**World Forum for Harmonization of Vehicle Regulations****Working Party on Lighting and Light-Signalling****Eightieth session**

**Other UN Regulations:****UN Regulation No. 53 (Installation of lighting and light-signalling devices for L<sub>3</sub> vehicles)****Proposal for a new supplement to the 01 series of amendments and to the 02 series of amendments to UN Regulation No. 53 (Installation of lighting and light-signalling devices for L<sub>3</sub> category vehicles)****Submitted by the expert from the International Motorcycle Manufacturers Association (IMMA) \***

### Observing area towards the apparent surface of exterior courtesy lamps

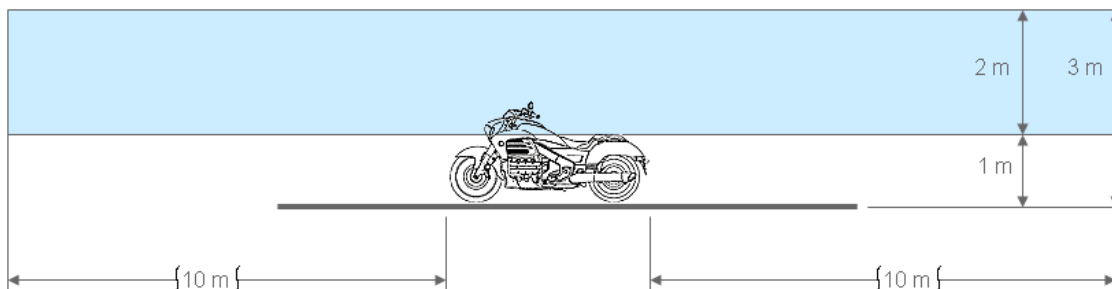
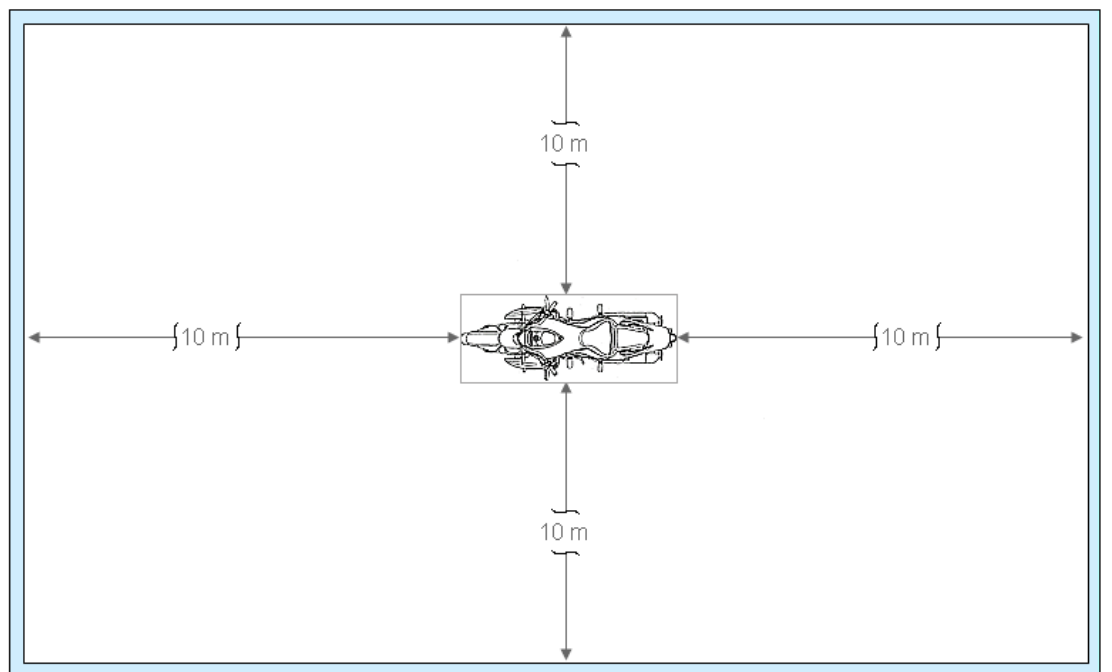
- 6.15.9.3. The technical service shall, to the satisfaction of the Type Approval Authority, perform a visual test to verify that there is no direct visibility of the apparent surface of the exterior courtesy lamps, if viewed by an observer moving on the boundary of a zone on a transverse plane 10 m from the front of the vehicle, a transverse plane 10 m from the rear of the vehicle, and two longitudinal planes 10 m from each side of the vehicle; these four planes to extend from 1 m to 3 m above and perpendicular to the ground as shown in Annex 7.

*Insert a new Annex 7, to read:*
